ALERT SERVICE BULLETIN

412CF-17-62
3 March 2017

SUBJECT: **MAGNETIC BRAKE ASSEMBLY 204-001-376-003, INSPECTION AND REPAIR OF.**

HELICOPTERS AFFECTED: Serial numbers 46400 through 46499.

Figure 1. Magnetic brake assembly.

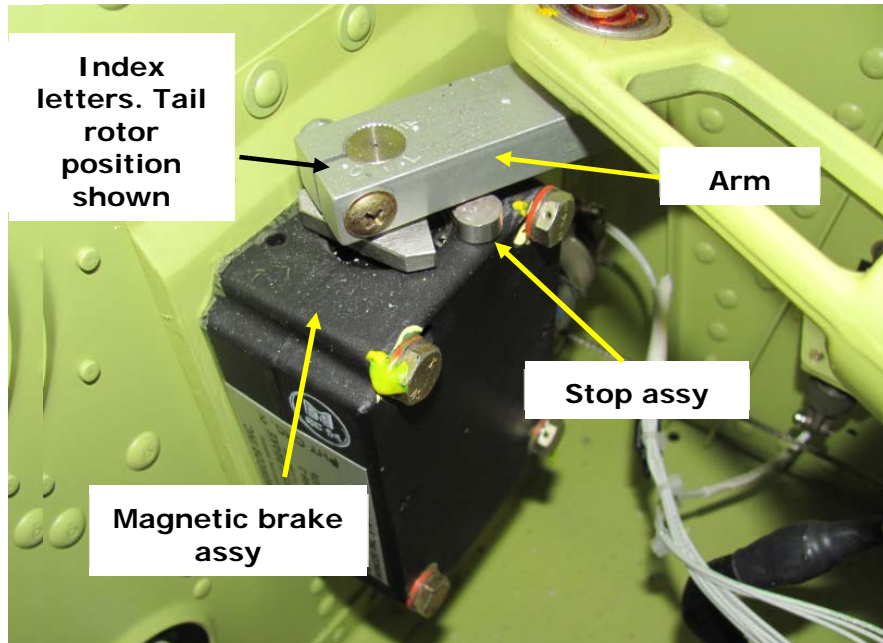
1. Prepare the helicopter for maintenance.
2. Gain access to the tail rotor magnetic brake assembly (C-12-146-000/MF-001).
3. Perform a detailed visual inspection of the stop assemblies (Figures 1 and 2). Figures 3 and 4 show a stop assembly found disbonded.

Figure 3. Stop assembly with disbonded shaft.

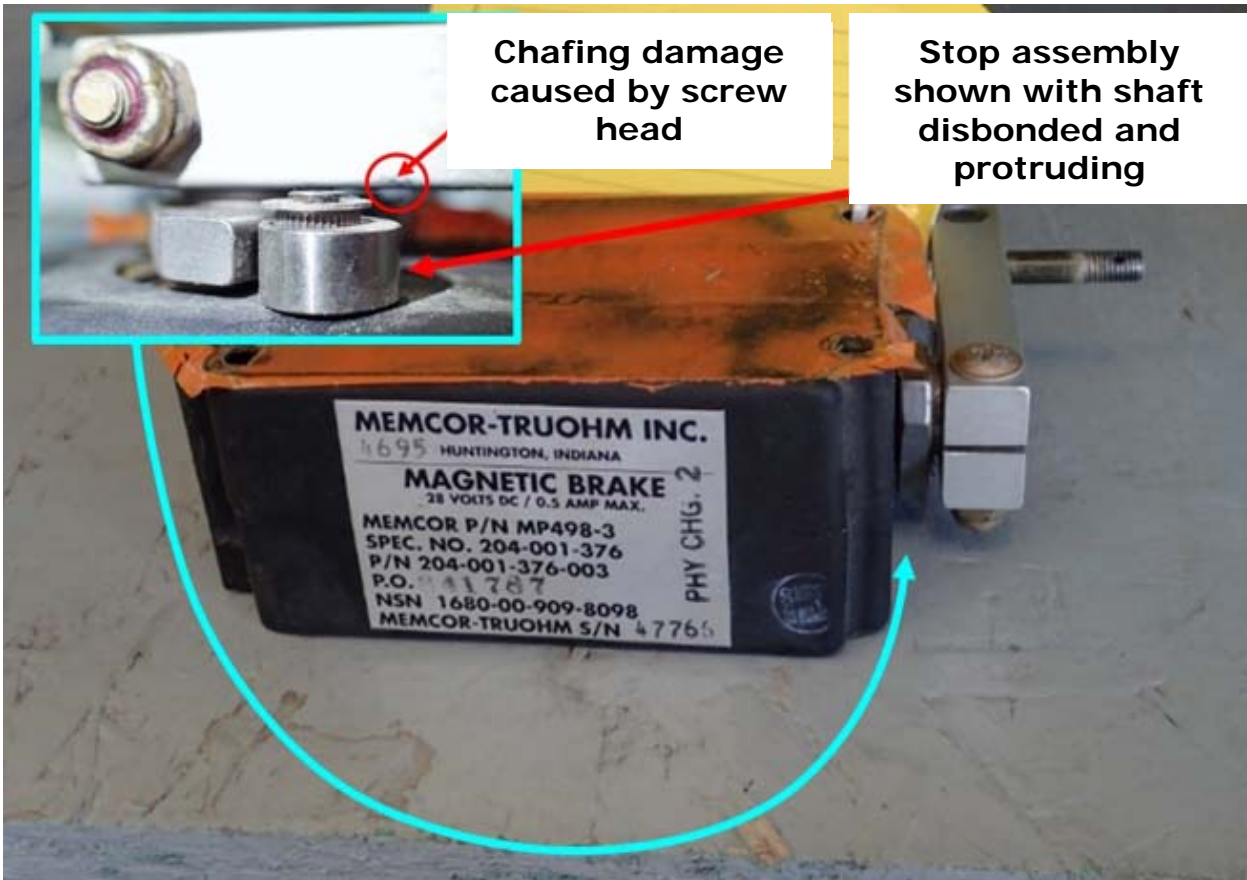
4. By hand, pull on the stop assembly to verify if the stop shaft is disbonded from the housing assembly.
5. If the shaft shows evidence of disbond, inspect the lower side of the arm for possible chafing damage and accomplish Part II. The maximum allowable mechanical damage is 0.030 inch. (0.762 mm).
